ENVIRONMENTAL SECTOR'S COMMENTS ON MTEP21 EGEAS RESULTS AND SITING CRITERIA

MTEP21 Sliddeck from 7-13-20:

The EO Sector appreciates the opportunity to provide comments to MISO regarding the most recent MTEP21 meeting, held on July 14, 2020. Generally, the EO Sector supports MISO's direction on the MTEP21 Futures process, and we encourage MISO staff to continue interacting with stakeholders and solicit feedback. We also encourage MISO to provide additional details about each future, including percentage of energy requirements met with renewable energy, trajectory of carbon emission reductions over time, and geographic and temporal granularity on retirements occurring in each Future. As discussed in more detail below, the results presented at the July 14th workshop indicate Future 1 and 2 may still be overly conservative and this additional information would help stakeholders better understand how these Futures do or do not reflect our understanding of ongoing and near term changes to MISO's resource portfolio.

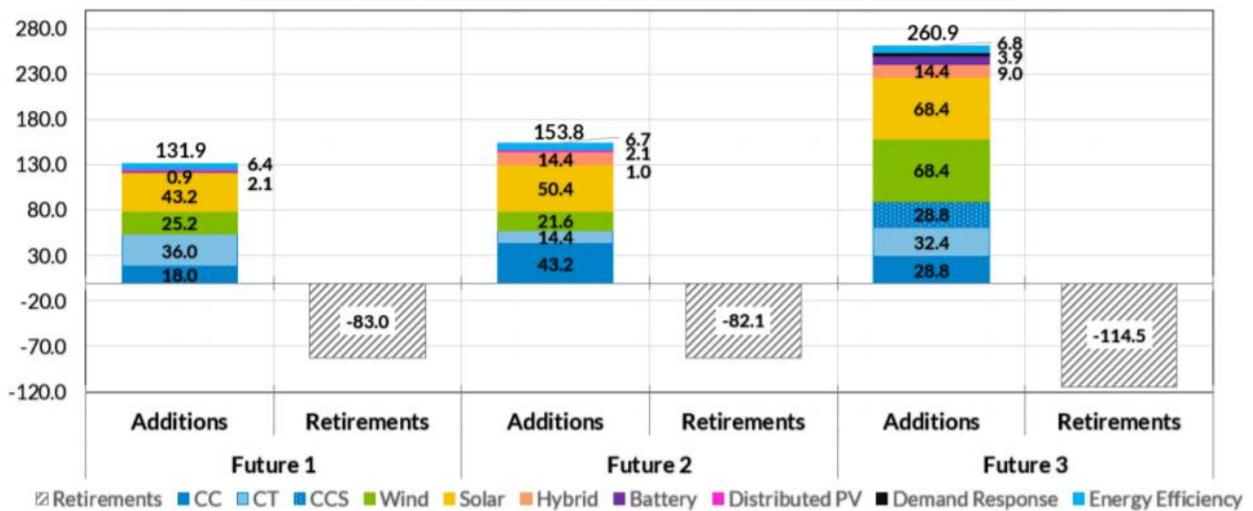
Capacity additions of new wind, solar, hybrid, and battery resources in the draft results of the MTEP21 show 69.3 GW added in Future 1, 87.4 GW in Future 2, and 160.2 GW in Future 3. These draft results show Future 1 and 2 are likely to be unrealistically conservative compared to the pace we expect to see across the MISO system in coming years. Some of the key indicators of this from the limited data MISO provided include:

- Only an 18 GW increase in renewable capacity in Future 2 compared to Future 1, Particularly considering the steep jump in renewables (73 GW) from Future 2 to Future 3.

- Wind additions *decline* by 3.6 GW from Future 1 to Future 2.
- Energy storage additions are unreasonably low and remain relatively unchanged from Future 1 to Future 2. The anticipated addition of just 1 GW of storage over the next two decades seems unreasonably low, particularly given the 2.7 GW of storage currently in the queue. This is likely due to EGEAS, as an LDC model, is unable to see the value in energy storage and therefore not deploy it adequately.

- No hybrid resources are included in Future 1. This is unrealistically low, especially given that Entergy Arkansas has already contracted for hybrid resources in 2020² and over 2.5 GW of hybrid resources are currently in the MISO Queue.³

- In addition, we also note the following from slide 5 of the July 14th presentation:
 - Hybrid resources do not increase from Future 2 to Future 3, remaining at a flat 14.4 GW. It is more likely that hybrid resources will increase between Future 2 to Future 3, as opposed to adding the full 28.8 GW of new CCS.

CCS Siting

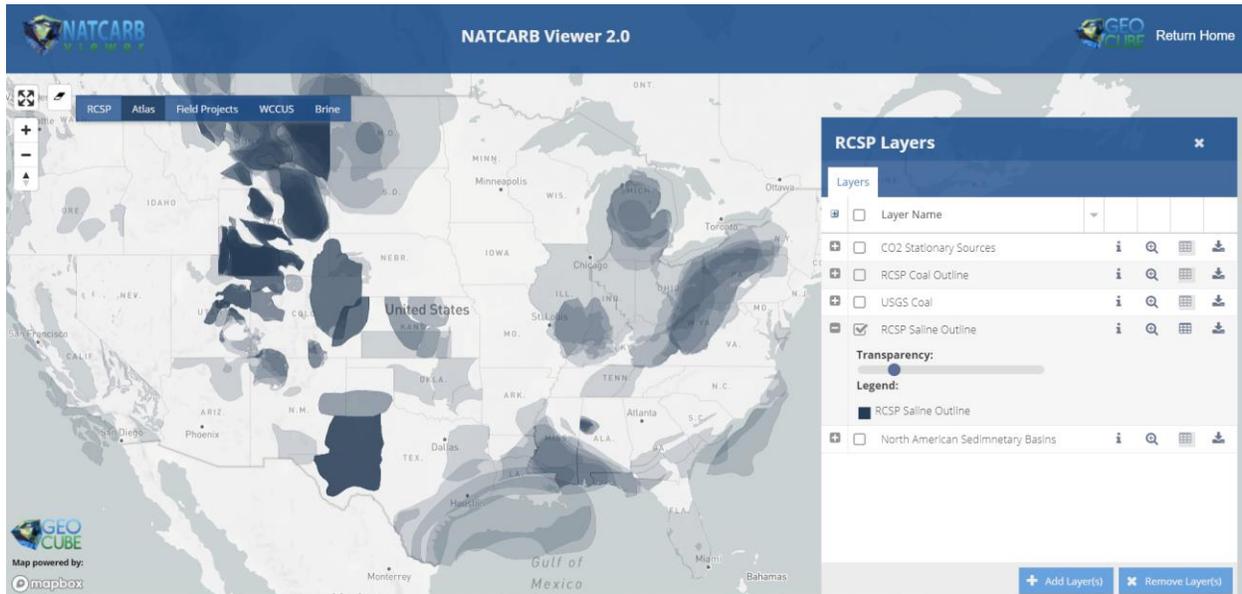
The EO Sector appreciates MISO’s efforts to resolve the higher levels of surplus energy in Future 3. Traditionally, surplus energy has been resolved in modeling exercises by either expanding transmission or curtailing generation resources. In sum, MISO’s modeling suggests that building surplus renewable energy is still a lower-cost option than adding fuel-based zero-carbon resources and is not necessarily an indication of flawed modeling, particularly given MISO’s regional-focused approach that does not consider increased capacity to move energy interregionally. Larger amounts of surplus renewable energy alone is not sufficient to justify forcing natural gas carbon capture and sequestration (CCS) into the model.

We encourage MISO to further evaluate stand-alone energy storage and hybrid resources as alternatives to the CCS built in Future 3 and are concerned that MISO risks falling behind the evolution of battery storage technology like it has for wind and solar resources over the past several years. Given the trajectory of cost and performance improvements over the past few years, we expect these resources to out-compete CCS and we request MISO evaluate opportunities to increase opportunities for storage and hybrid resources while reducing CCS deployment. At a presentation given by GTM Research in 2018, cost forecasts for energy storage showed that within ten years, energy storage would always be the cheaper option compared to new combustion turbine gas units.¹⁰ Under Future 3, it is reasonable to expect fuel-sector greenhouse gas reduction policies in conjunction with electricity and transportation sector policies already reflected in Future 3, meaning CCS will not be considered a “zero-emission” resource given significant upstream greenhouse gas emissions. At a minimum, we would request MISO review the latest cost and performance assumptions released through the 2020 ATB that was published in June. Further, we recommend MISO evaluate its various planning and forecasting software programs to determine if improved software suites are needed.

MISO staff have created some new siting methodology recommendations regarding natural gas CCS. As one parameter, MISO staff recommended using a map of viable locations for long-term CO₂ storage; however, the map provided appears to include multiple geologic formations, including formations that are typically used for advanced petroleum recovery efforts - something that is less likely to take place in a low-carbon future. As such, perhaps only geographies with

saline-based geologic formations should be considered.¹¹ Salt dome caverns are well-known facilities that could be repurposed for long-term greenhouse gas emission storage.

Further, while we agree that siting CCS resources in areas with easy access to CO2 storage locations will reduce costs, all other things being equal, we encourage MISO to also consider the potential interconnection costs, line losses, and other cost elements of these resources if sited in remote or weak areas of the MISO grid. Pipeline construction for CO2 will add cost to a CCS project, but project developers will ultimately weigh that against other costs such as these to find optimal sites.
